13th March 2025

Re: Interbridges, New Brighton Road, Emsworth (LPA ref. APP/24/01010)

Bellamy Roberts has been instructed by PNH Properties to prepare a written response to the consultation comments received from the lead Local Flood Authority (LLFA) dated 10th February 2025.

Figure 1: Surface Water Flood Risk

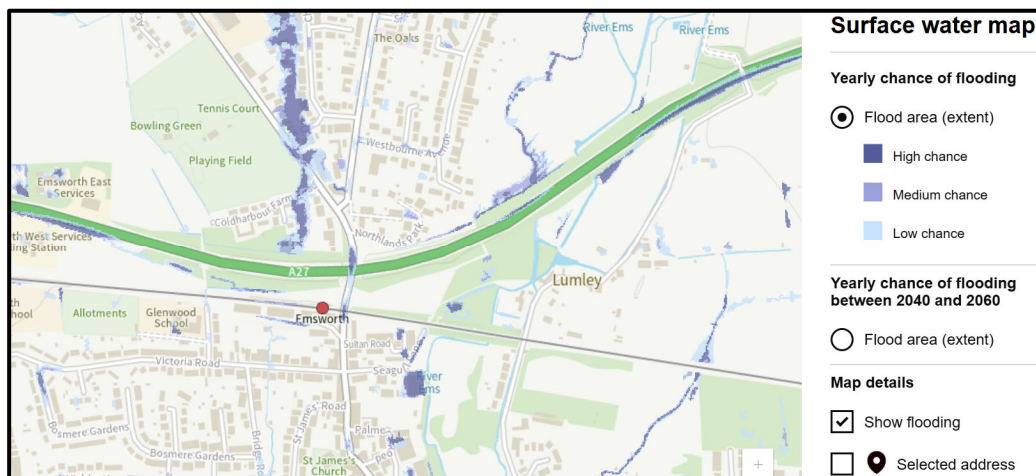
Surface Water

Regarding surface water flood risk, the updated published mapping now shows no surface water flood risk within the boundary of the site. This is also the case when the future period 2040 – 2060 is considered. This is evidence at Figure 1 and 2.
